SUBJECT: AMENDMENT NO. 126 TO FACILITY OPERATING LICENSE NO. DPR-58
(TAC NO. 71062)

DONALD C. COOK NUCLEAR PLANT, UNIT NO. 1

Amendment No. 126
License No. DPR-58

SAFETY EVALUATION BY THE OFFICE OF NUCLEAR REACTOR REGULATION
RELATED TO AMENDMENT NO.126 TO FACILITY OPERATING LICENSE NO. DPR-58
INDIANA MICHIGAN POWER COMPANY
DONALD C. COOK NUCLEAR PLANT, UNIT NO. 1
DOCKET NO. 50-315

Figure 2. 1-1 Reactor Core Safety Limits
Four Loops In Operation

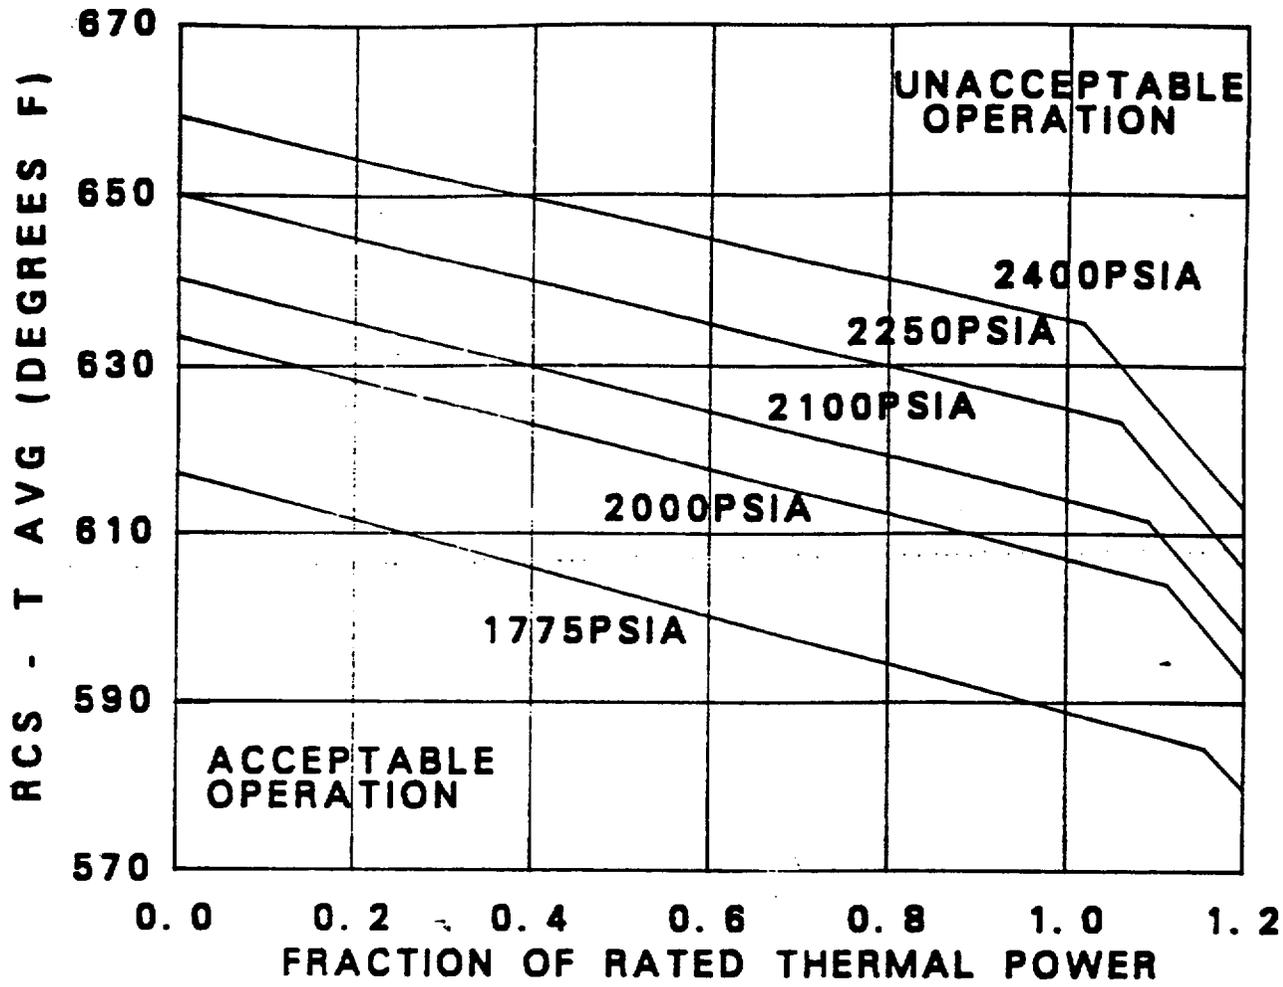
3. Figure 2.1-1 on page 2-2 is being revised to reflect the revised DNBR safety limit of 1.45. This change is acceptable because it is supported by the safety analysis.

FIGURE 3. 2-3

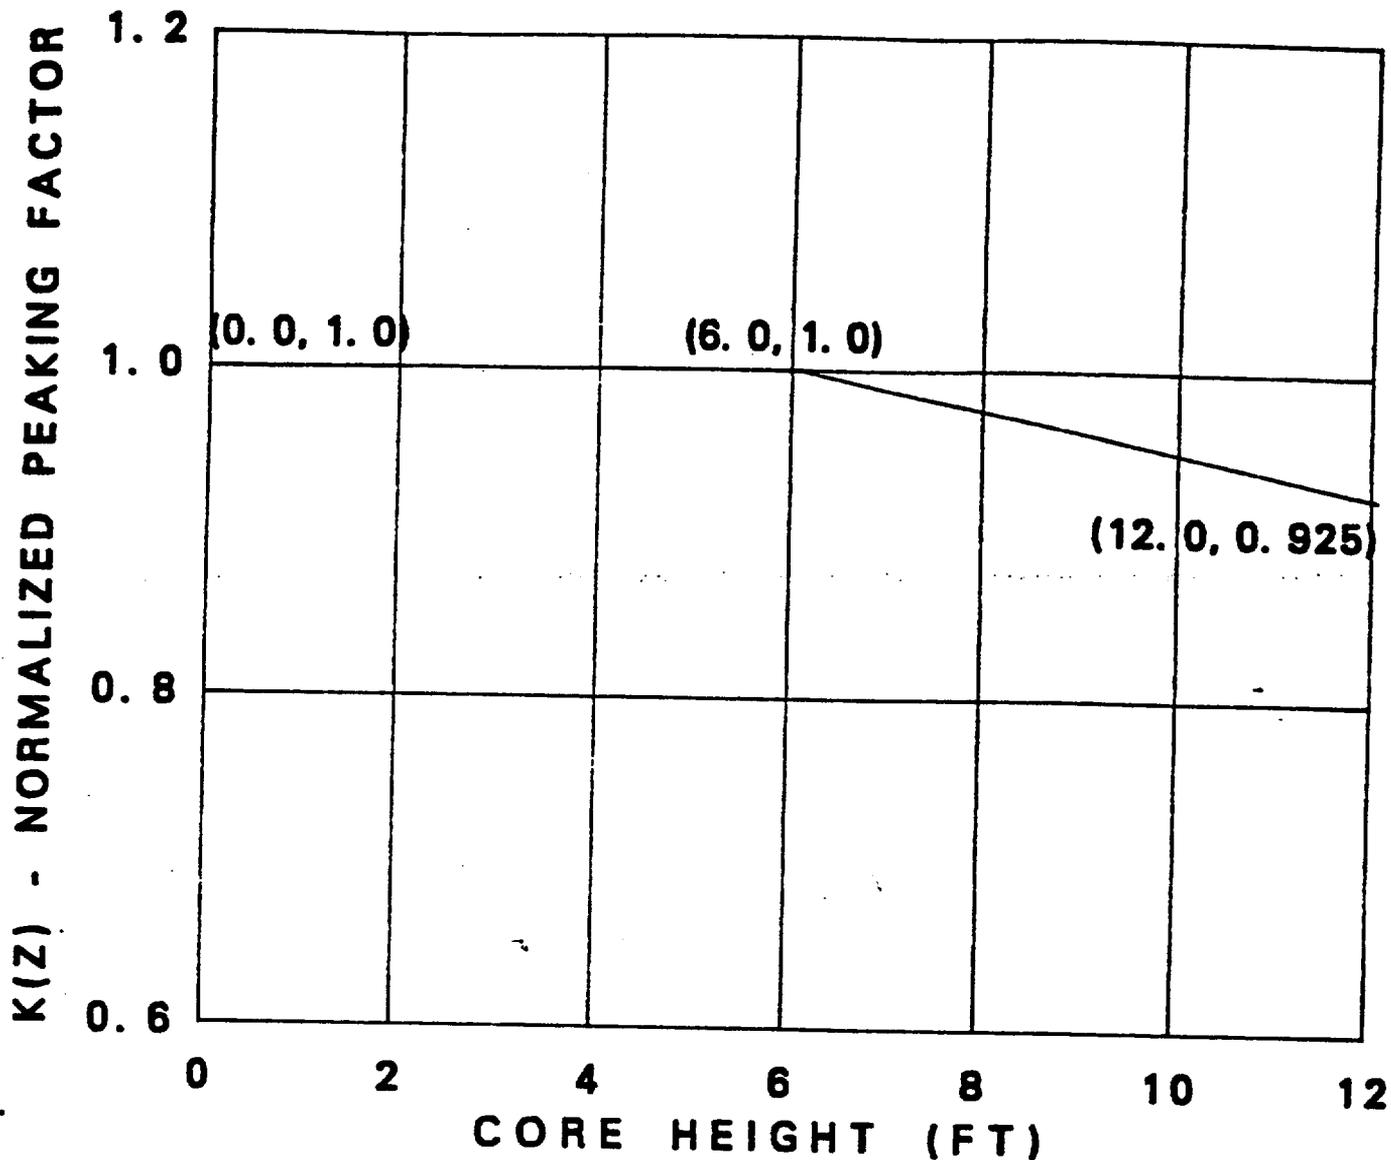
9. The K(Z) curve for Westinghouse fuel (page 3/4 2-8) is being revised. This is acceptable because it is supported by the new LOCA analysis for Cook Unit 1.
